Product Change Notification

Date Issued :	July 22, 2022	PCN Number :	512372
Reason for Change :	Equipment Transfer, Production Transfer or Rearrangement		
Description of Change :	This notification is to inform you about an equipment transfer that has been used to manufacture impacted part(s). Equipment has been moved to different site/ location/ premises. No changes will be made to product part, fit nor function as part of this change.		
Reason for Short Notice :	Capacity Increase		
Assessment of Change :	No change to parts - Form/Fit/Function Dimension analysis		
Planned Implementation Date :	October 07, 2022		
Sample Availability Date:	September 19, 2022		
Internal Molex Qualification Date :	September 26, 2022		
Last date to request Samples by Customer :	September 16, 2022		
Traceability Code Markings / Date :	Date code

Guadalajara 2

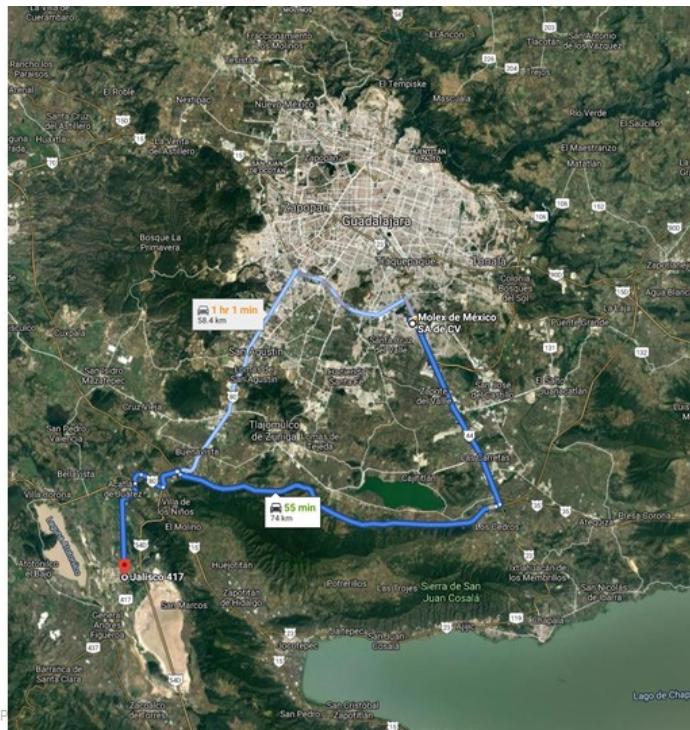
- Located in Centro Logistico Jalisco Industrial Park
- 1 hour from existing Guad1
- Initial build will contain Molding, Assembly, and Reliability Testing capabilities
- A new Distribution Center will service Guad2
- Start of Production targeted for Q4 2022
